**DEVIATION REQUEST** (Attach diagrams, figures, and other documentation to clarify request)

A deviation from the standards of or in Section **2.3.2 & 2.3.3** of the Engineering Criteria Manual (ECM) is requested.

SUBDIVISION CONCEPT PLAN

CIMARRON HILLS SOUTHEAST  
 MIXED USE FILING NO.1

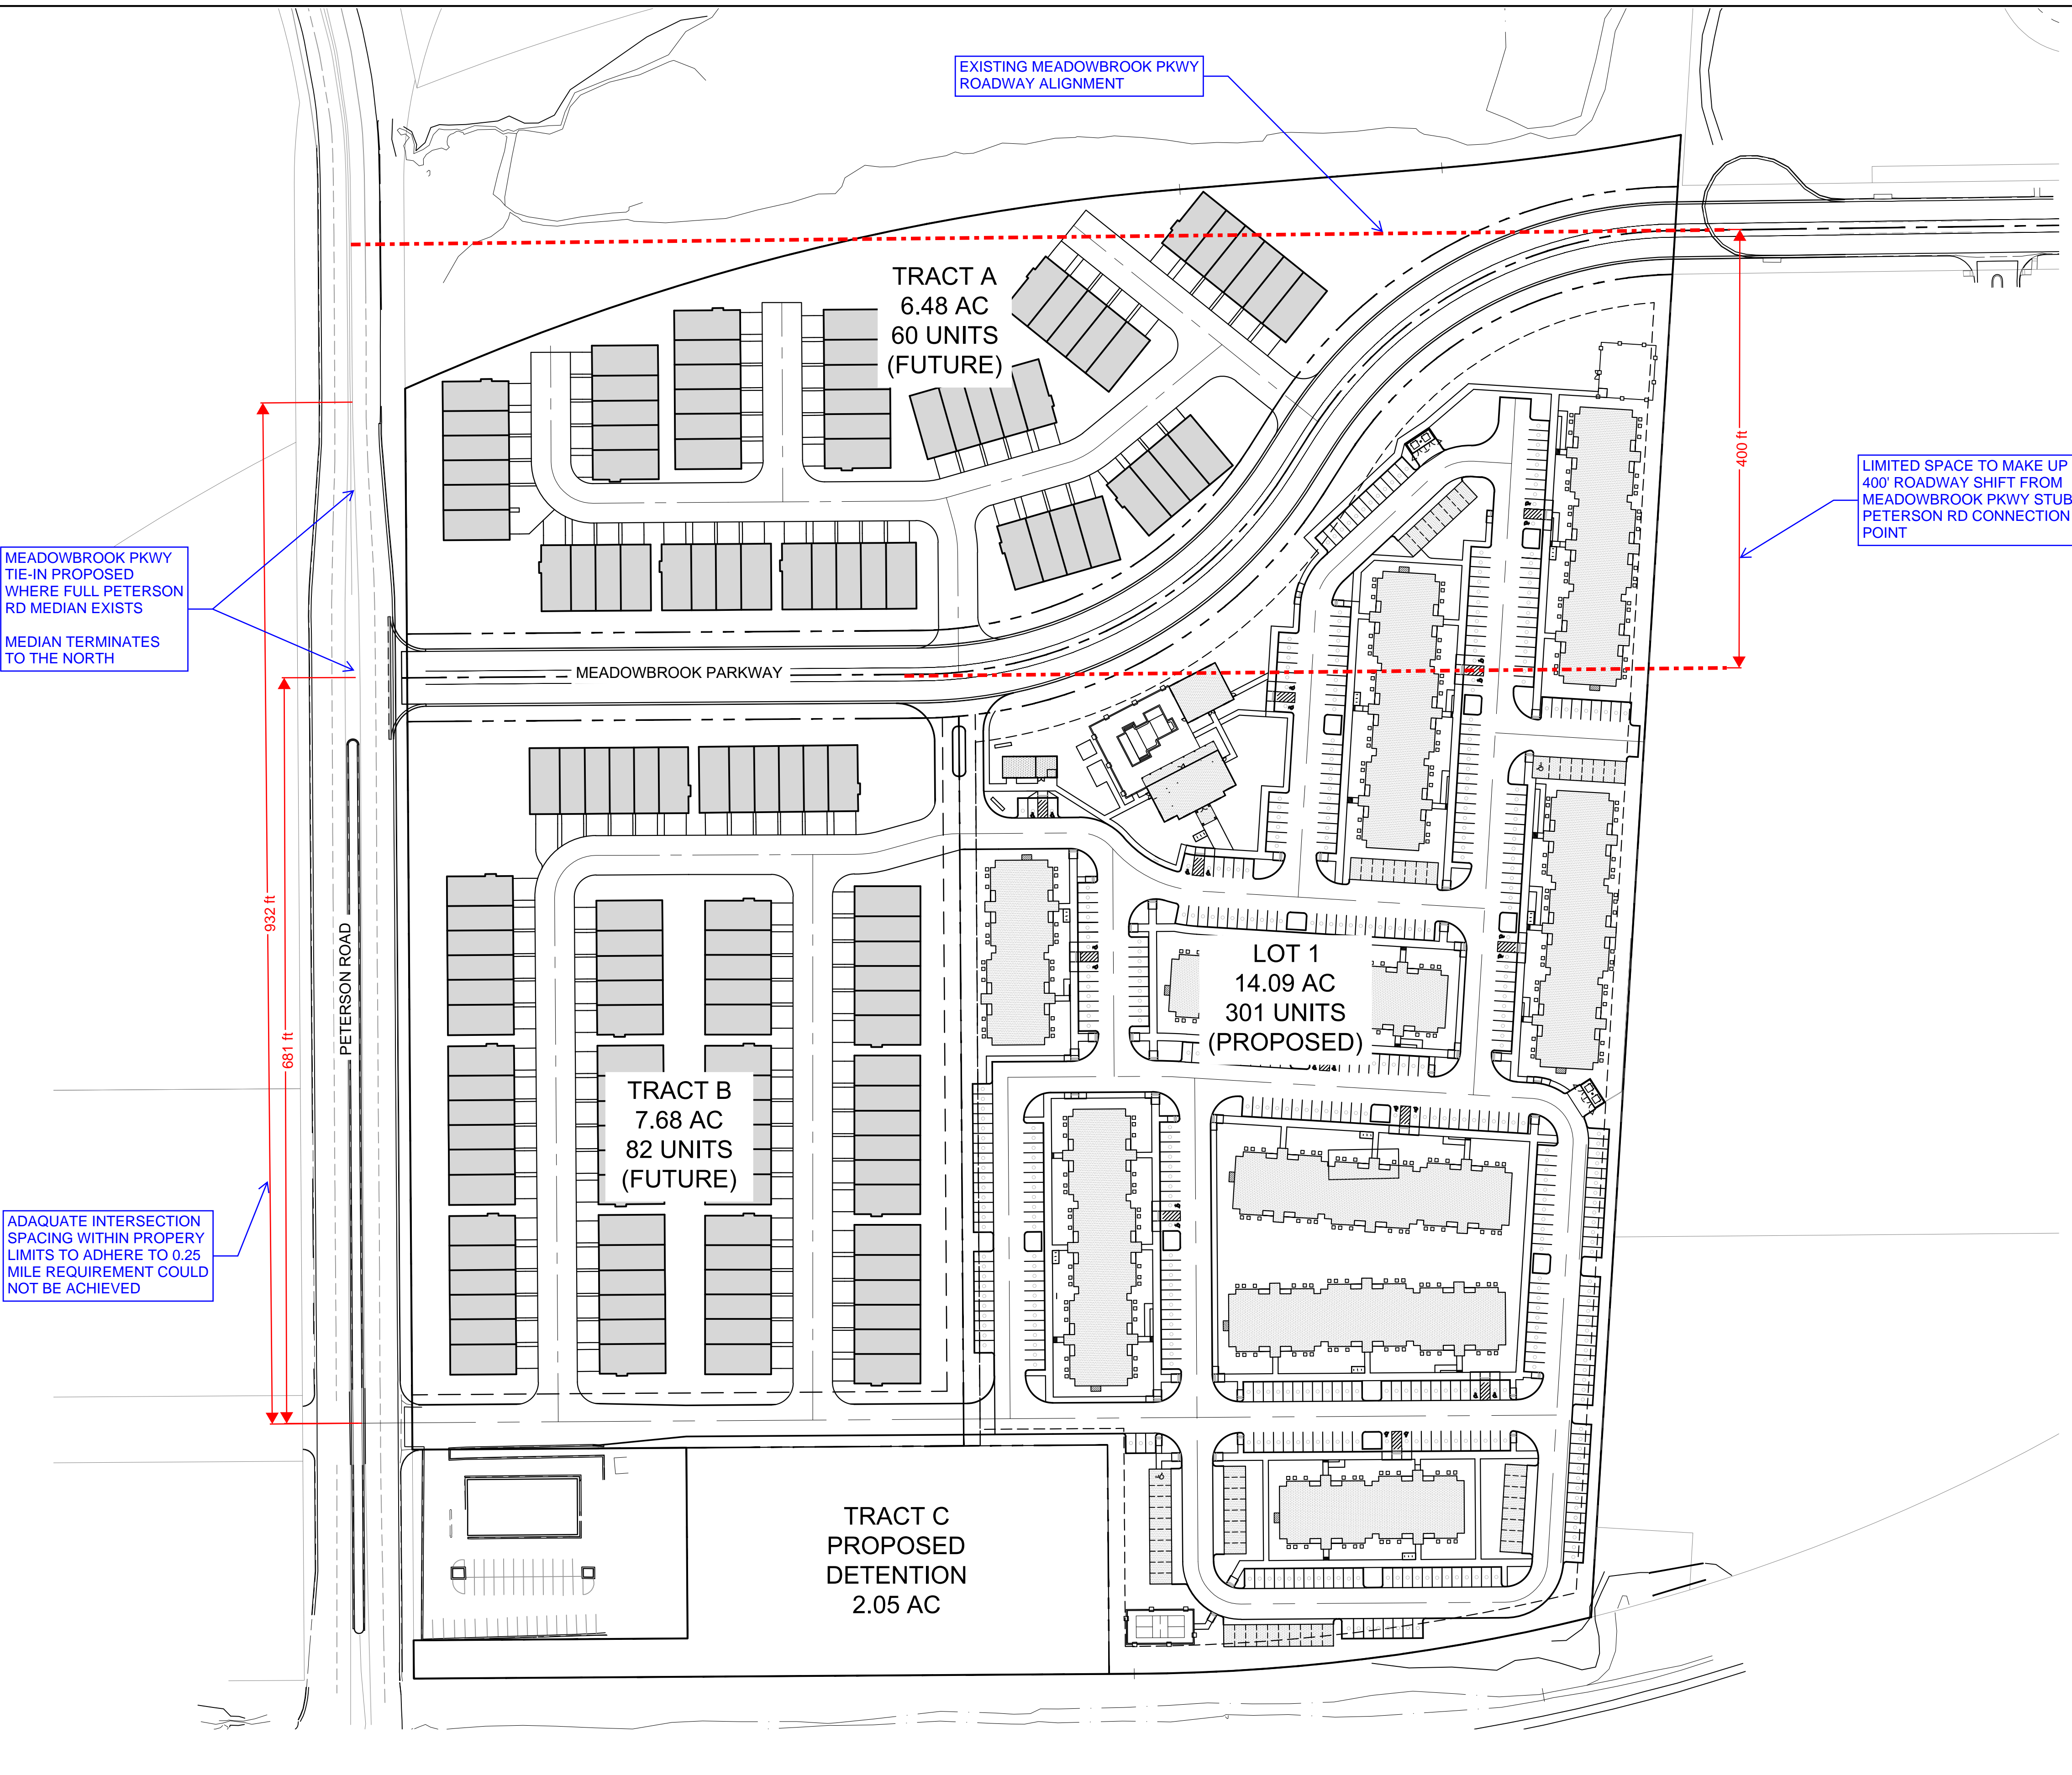
The proposed design of Meadowbrook Parkway extension to Peterson Road will have two (2) 400' curve radiuses used. This deviates from the 565' minimum centerline curve radius requirement found in Table 2-7 of El Paso County ECM for a Non-Residential Collector roadway. There will also be a 40' tangent length between the reverse curves which deviate from the minimum 150' tangent length requirement found in table 2-10. Additionally, the intersection spacing for the connection of Meadowbrook Parkway to Peterson Rd does not meet the 0.25-mile requirement for a Minor Arterial roadway found in Table 2-6. All other roadway specifications horizontally and vertically have been met. The proposed extension of Meadowbrook Parkway is 30 mph.

The first deviation is from the 565' minimum centerline curve radius requirement found in Table 2-7 of the El Paso County ECM for a Non-Residential Collector roadway. The proposed alternative was to provide a 400' curve radius and reduce the speed limit on the Meadowbrook Pkwy extension to 30 mph.

The second deviation is from the 150' tangent length requirement found in Table 2-10 for a Collector roadway. The proposed alternative was to provide a 40' tangent length and reduce the speed limit on Meadowbrook Pkwy to 30 mph.

The third deviation is from the 0.25-mile intersection spacing requirement found in Table 2-6 of the El Paso County ECM for a Minor Arterial roadway. The proposed alternatives were limited due to the spacing from the existing Panamint Ct/ Peterson Rd intersection to the northern boundary of the subdivision being only 0.20 miles apart. The posted speed limit on Peterson Rd for this stretch of roadway is 30 mph, which is less than the 35 mph posted speed listed in table 2-6 of the El Paso County ECM.

This request has been determined to have met the criteria for approval. A deviation from Section 2.3.2 & 2.3.3 of the ECM is hereby granted based on the justification provided.
